APPLICATION NO.	FILING DATE	FIRST NAMED INVENTOR	ATTORNEY DOCKET NO.	CONFIRMATION NO.
09/998,972	10/31/2001	Christopher Rogers	DEP 0639	6510

Office Action Summary

- 1) ☒ Responsive to communication(s) filed on 31 December 2003.
- 2a) ☒ This action is **FINAL**. 2b) ☐ This action is non-final.
- 3) ☐ Since this application is in condition for allowance except for formal matters, prosecution as to the merits is closed in accordance with the practice under *Ex parte Quayle*, 1935 C.D. 11, 453 O.G. 213.

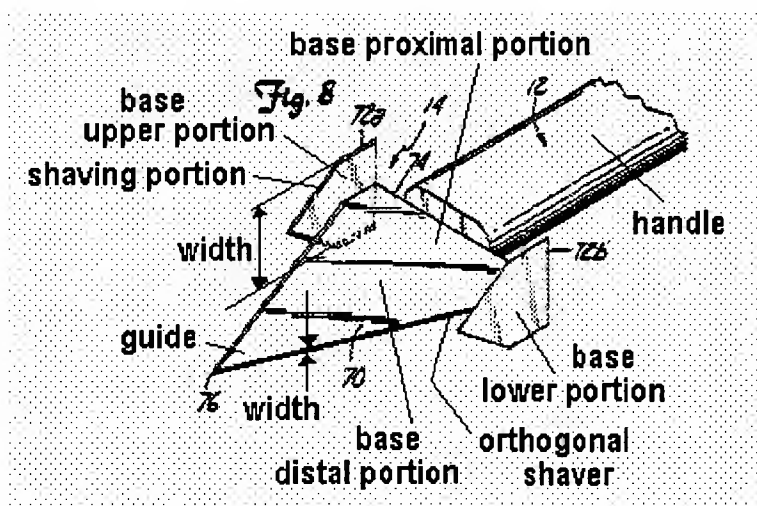
Claims 1-12, 15, 18, 22-24 and 38-44 are rejected under 35 U.S.C. 102(a) as being anticipated by Ray et al (US 5,649,945).

Note the identified structure in Ray et al Figure 8. The intent by applicant that tool be used with base upper and lower portions in a horizontal position rather than a vertical position, fails to provide for any objectively ascertainable structural distinctions between the claimed device and that disclosed by Ray et al.

In regard to claim 4, note the optional handle of Figure 9. In regard to claim 5, note the retraction means 28 (recess).

In response to the present rejection applicant argues that Ray et al fails to disclose a "guide" and then declares that a "guide is a non-cutting member that helps align the chisel if the chisel were somehow misaligned, thereby insuring that equal amounts of material are removed from the upper and lower workpiece portions." Unfortunately, the rejected claims fail to include such defining language. The examiner

would readily withdraw the present rejection if such language were included in the claim. Applicant's apparent position that the examiner and the public somehow read applicant's mind and interpret the general term "guide" in such a manner is unreasonable.
